## **NOTICE TO CONTRACTORS BIDDING THIS PROJECT**

Project Title: Building and Site Improvements at 6741 Downing Avenue, Bakersfield, CA

Contract No: 26016

### **ADDENDUM No. 2**

|     | <b>A100A</b> |

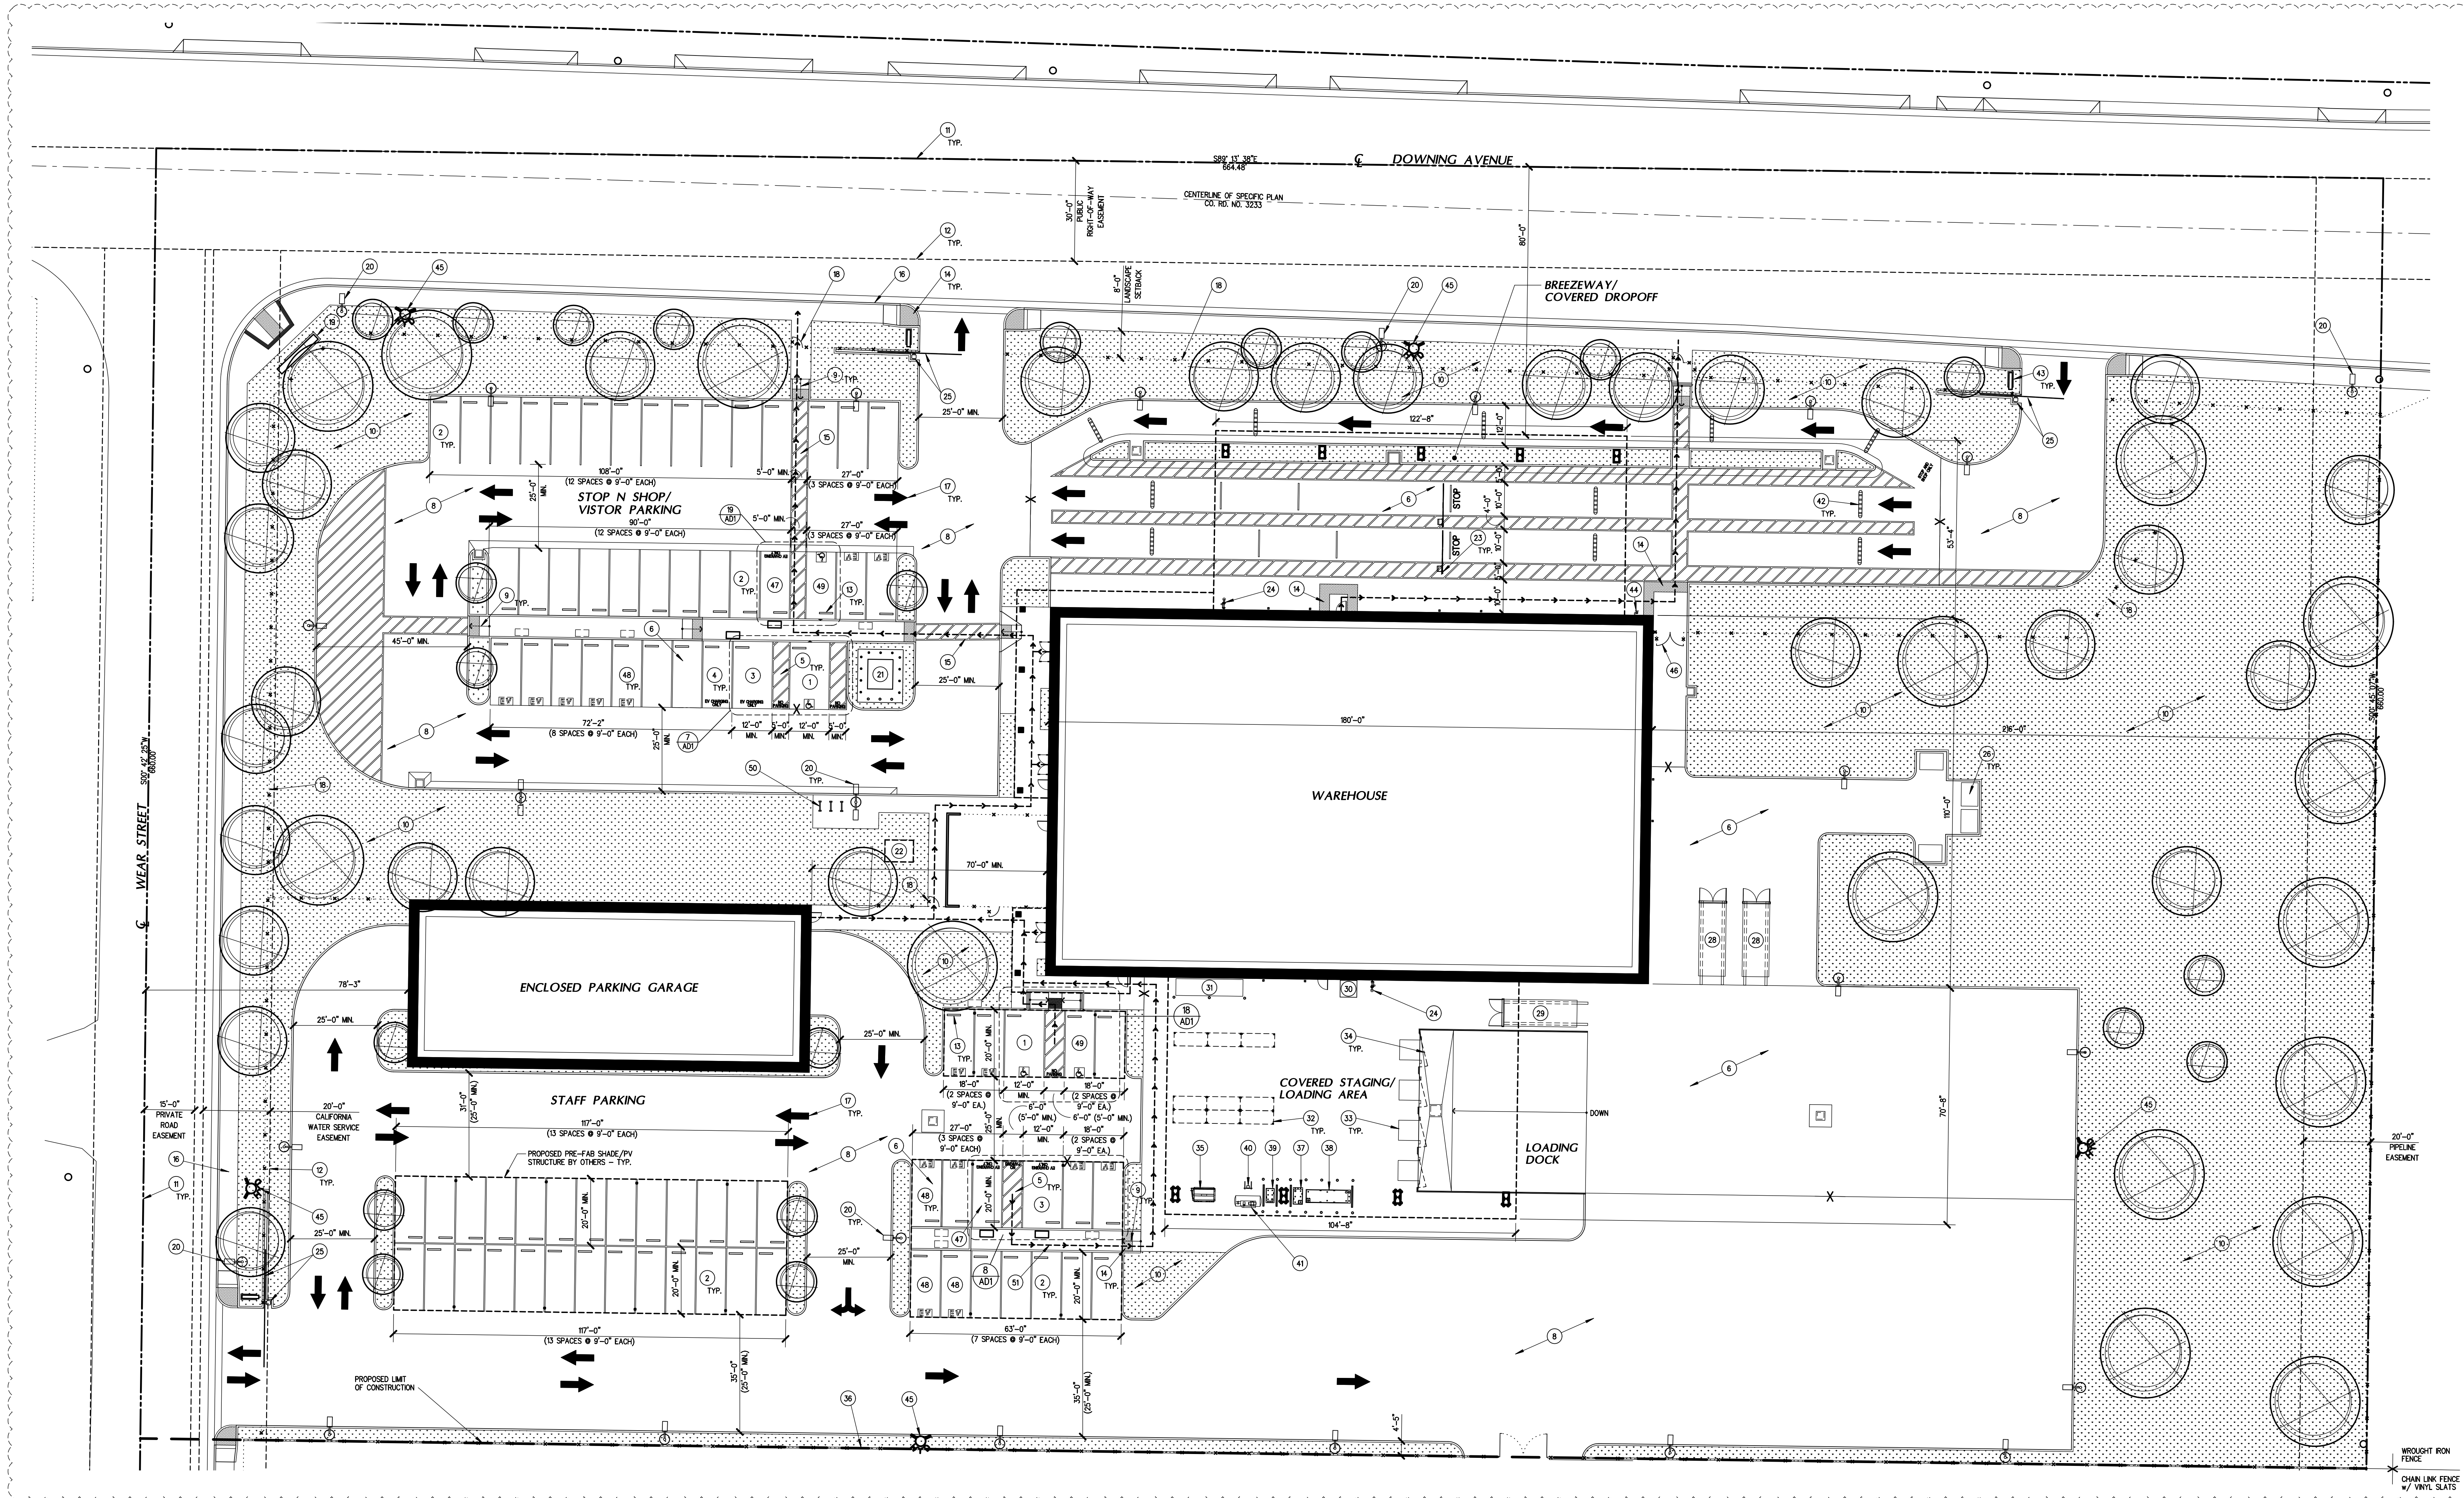
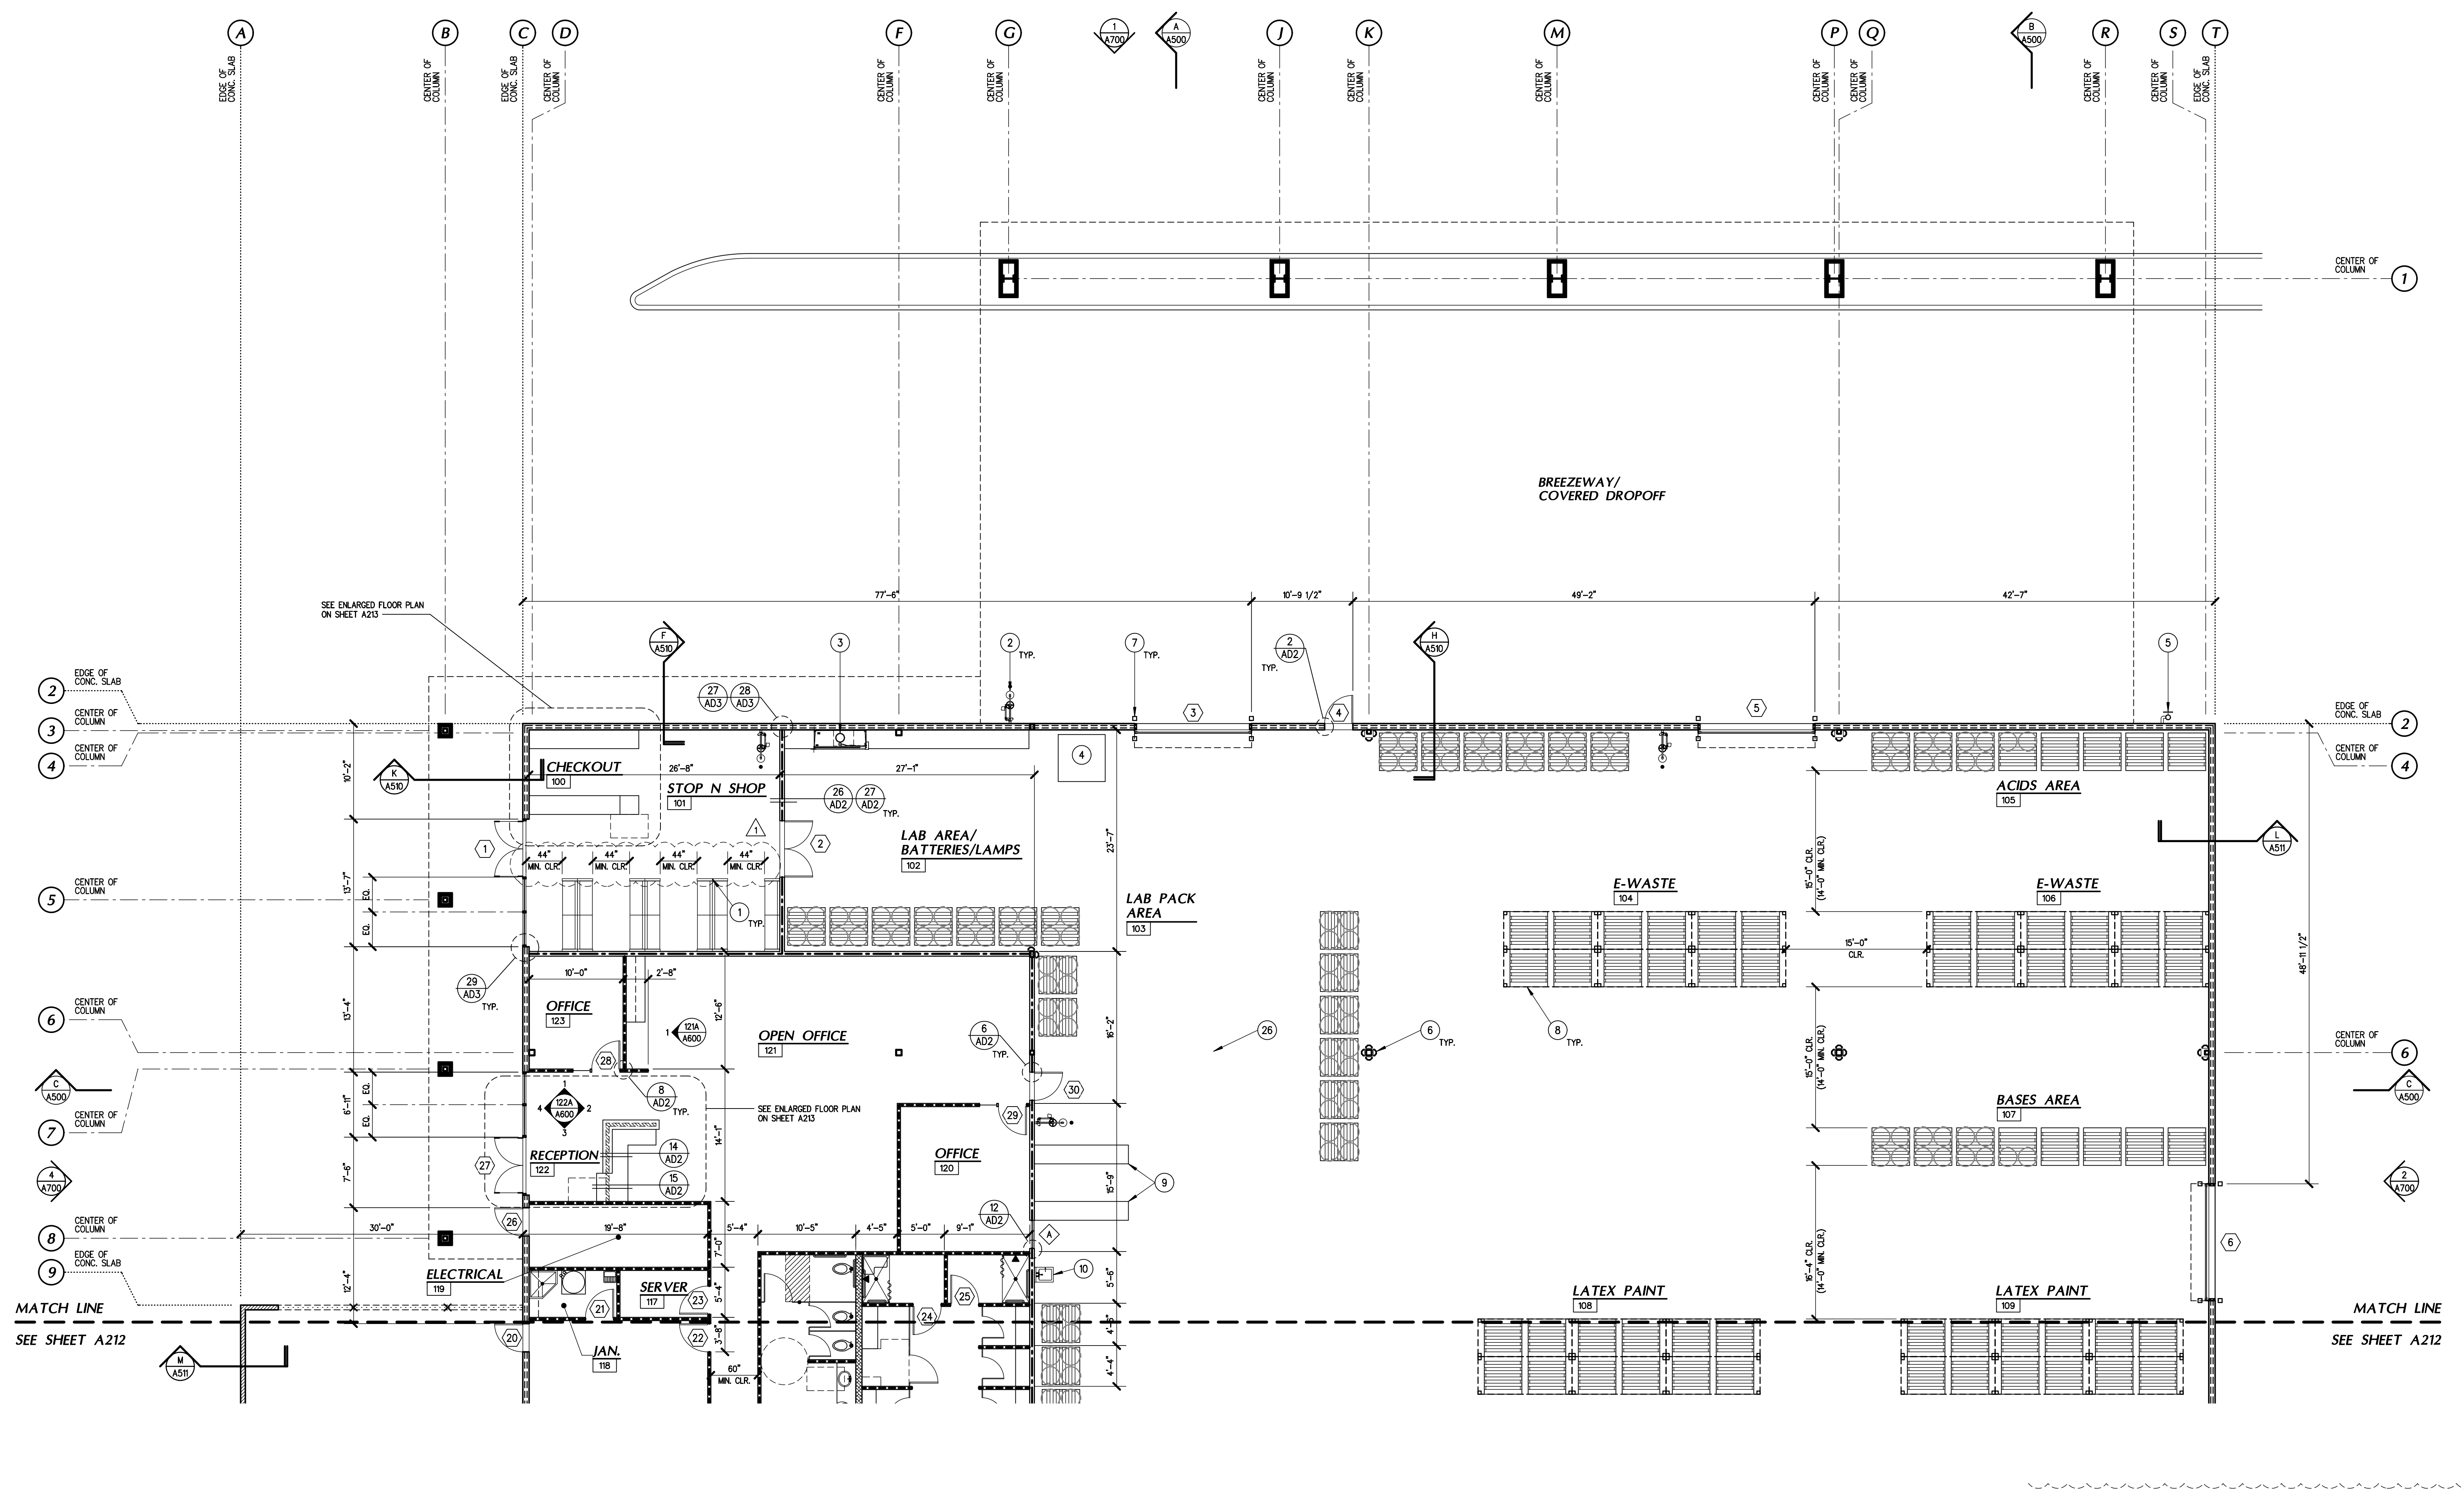
- a. Sheet A100 has been replaced with sheet A100A. The revised sheet clarifies the material of the rolling gates. Please see site keynote #25.
- b. Sheets A211 and A212 have been replaced with sheets A211A and A212A. The revised sheets include additional information regarding the explosion relief panels. The revised sheets are attached to this addendum.

**ROOF PLAN**

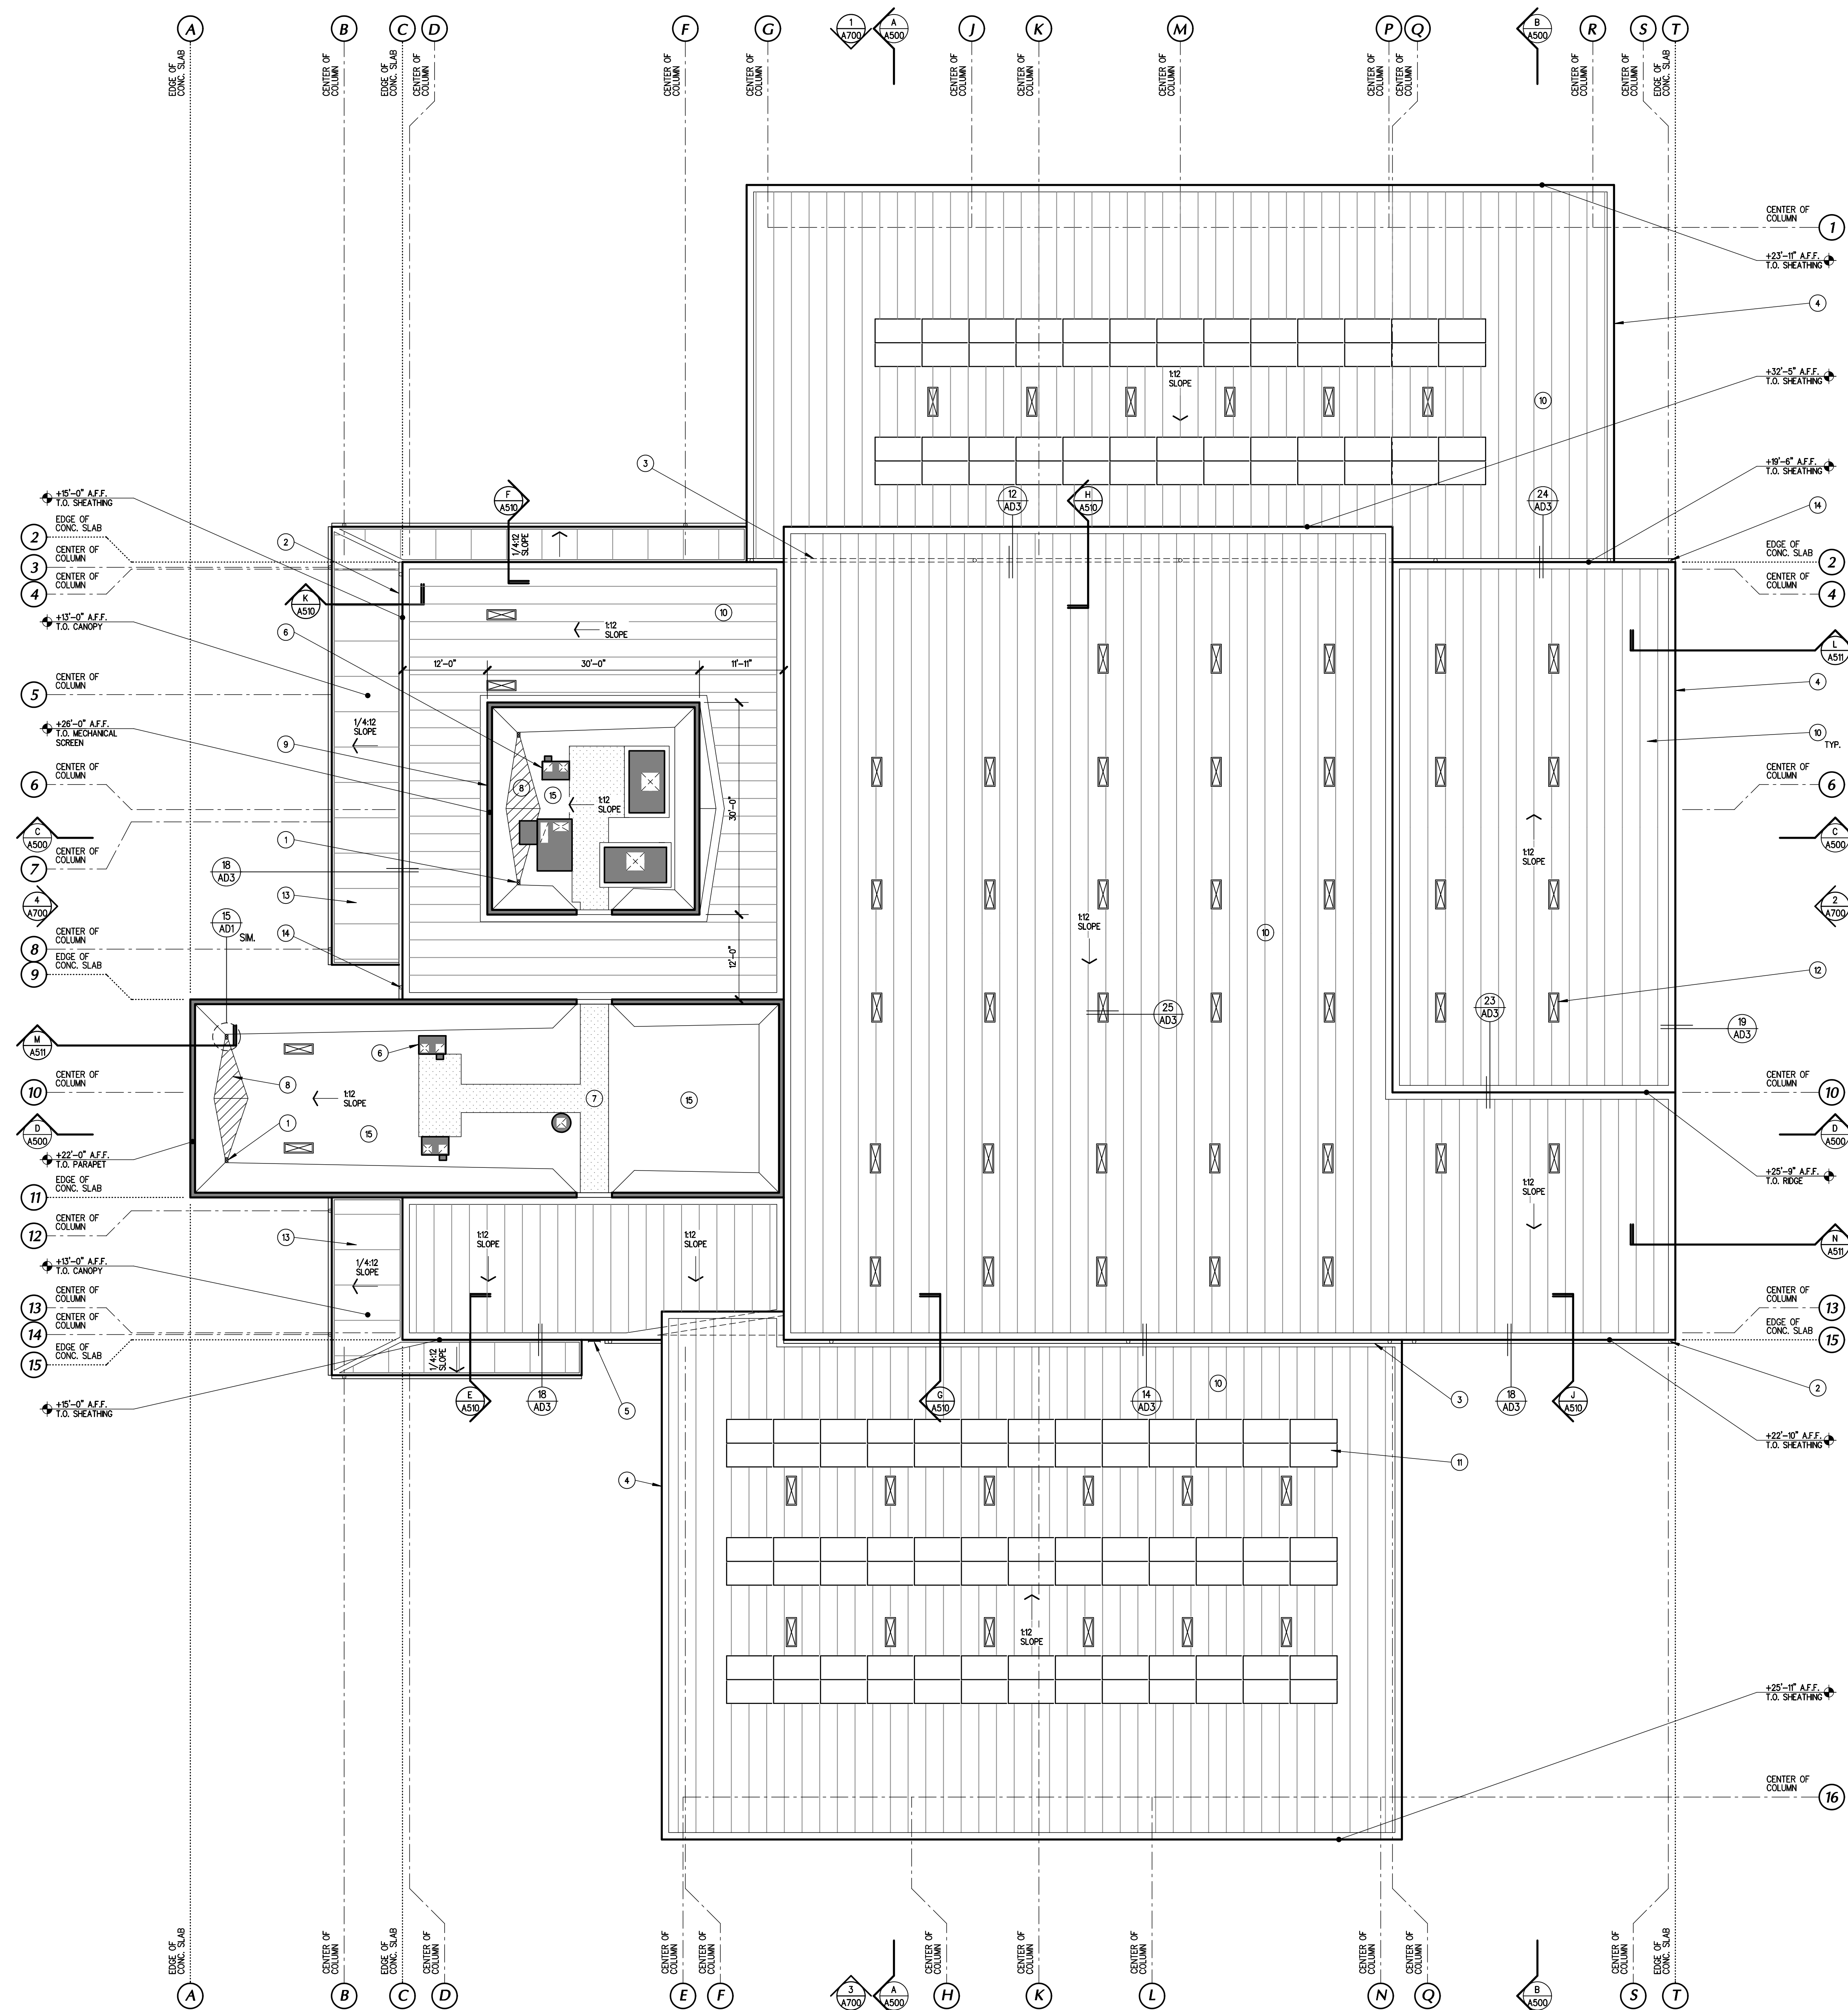
- c. Sheet A214 has been replaced with sheet A214A. Door hardware schedule has been added. The revised sheet is attached to this addendum.
- d. Sheet A400 has been replaced with sheet A400A. The revised sheet includes TPO and roof drain downspout information. The revised sheet is attached to this addendum. Please see roof keynotes #14 and #15.
